# Mount Perisher, Perisher Valley, Chairlift Replacement Modification

Modification Application Assessment (MOD 24/11703 (DA 10115 MOD 1))

November 2024

Published by the NSW Department of Planning, Housing and Infrastructure

Figure 6 | Elevation view of top station, with proposed Stage 1 (top without enclosure) and Stage 2 works illustrated (Source: Applicant's documentation)

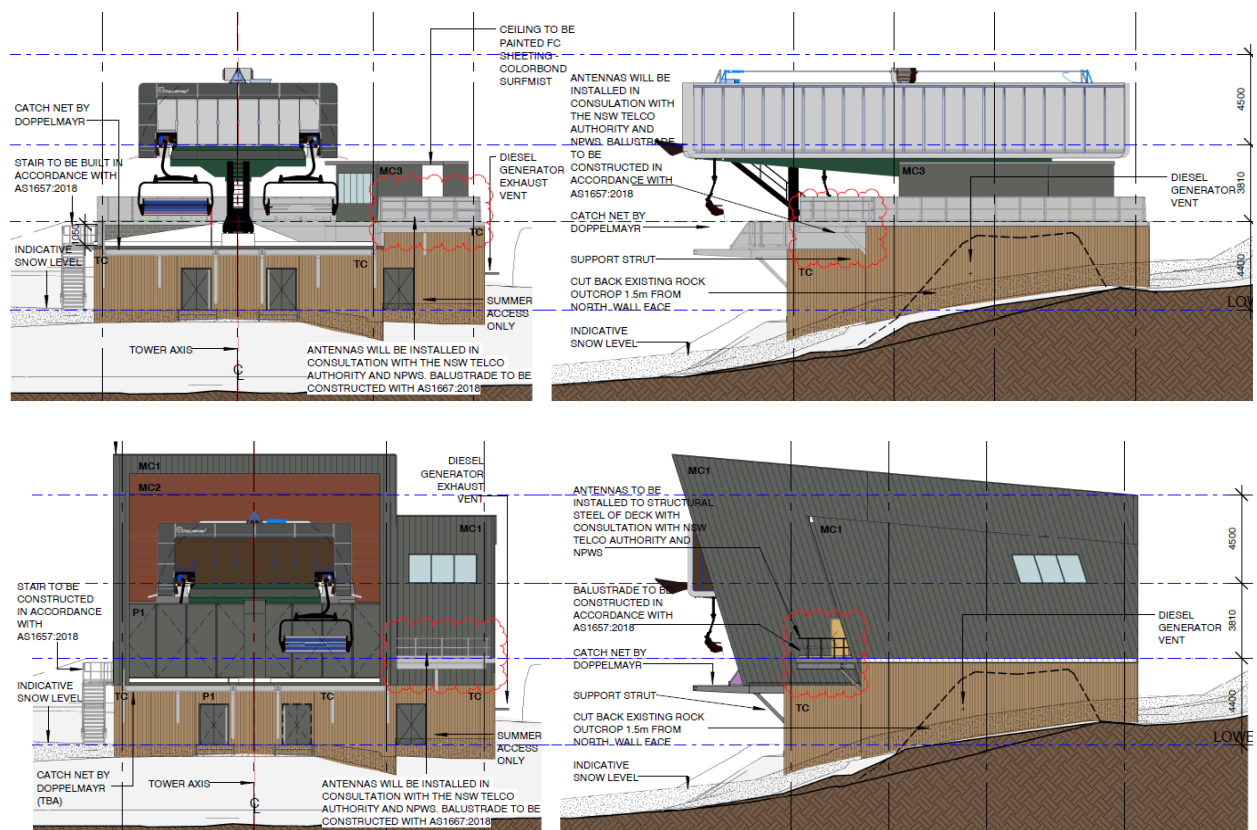
The Applicant intends to stage the top station as shown in **Figure 6**, with the main Doppelmayr station to be constructed as part of Stage 1 and the enclosure over the station to be completed as part of Stage 2.

In addition to staging of the works, other amendments to the top station include:

- rearrangement of control hut space
- removal of maintenance area and associated platform
- addition of southern external access stairs

- change of finish to lift control hut to metal cladding
- addition of internal access doors to lower ground level spaces
- addition of perimeter balustrading to ground Level

**Figure 9 |** Impression of approved top station and Stage 1 works (highlighted yellow) (Source: Applicant's modification documentation)

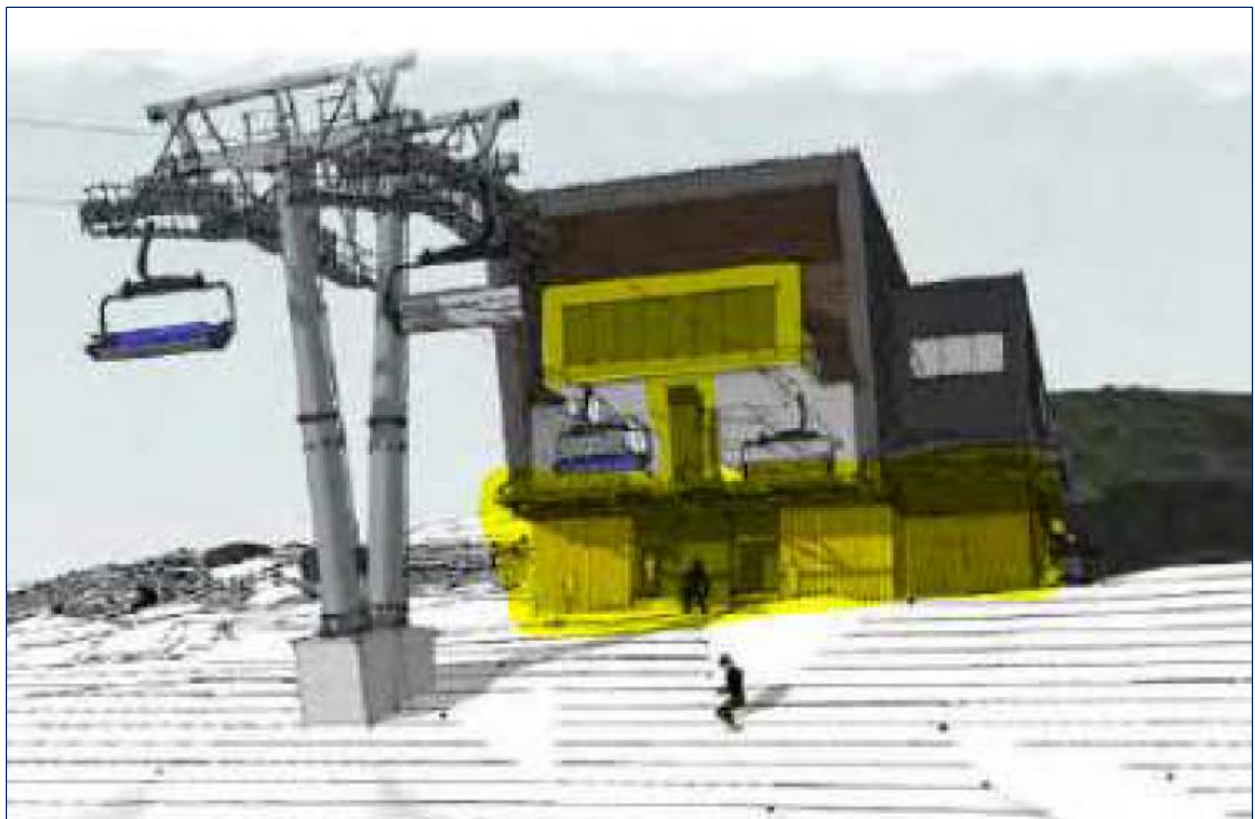
To support the stage 1 visual impact considerations, the Applicant further comments that the:

- Stage 1 top station is of a lower scale to Stage 2 as it does not include the roof and upper side wall elements. Due to the removal of these elements from Stage 1 the structure will be of a reduced height and scale and have visual permeability through to the landscape behind, resulting in a reduced visual impact when compared to the approved stage 2 design.

- The stations as constructed in stage 1 will have visual permeability to the landscape beyond and are consistent with the design of other chairlift stations in the resort. The colours and materials used are low reflective and in colours that blend with the natural environment. The approved chairlift top station sits below the top of the ridgeline and is replacing two chairlifts and as a result is an expected element in the landscape.

- The stage 1 top station built form will have a lower height to stage 2 as stage 1 effectively sits within the final stage 2 station. As seen in the approved rendered images of the stage 2 structure (**Figure 9**). Visual impact is reduced when a structure is anticipated in the environment. Stage 1 is consistent with the visual form of other such infrastructure in the resort and is of a form which is expected in the environment.

The Department's assessment has considered the proposed works to be completed under stage 1, the existing landscape and existing ski lifting infrastructure within the Perisher landscape.

The stage 1 works would complete the main lifting components of the developments, with the exception of the covered roof. This would be consistent with other ski lifting infrastructure such as the Village 8 and Leichhardt chairlifts within the immediate locality. Maintaining the top station in the existing landscape, with the completion of the ground floor slab, no additional views would be impacted than previously considered acceptable with completion of the stage 1 works.

The visual impact of the stage 1 component therefore does not raise any adverse visual impact as the completion of stage 1 works would be consistent with other existing infrastructure and continues to be incorporated within the landscape. Were the Applicant to construct stage 2 in the future, this visual impact was previously considered acceptable during consideration of the original application.

The Department raises no concerns with the proposal to stage the construction.
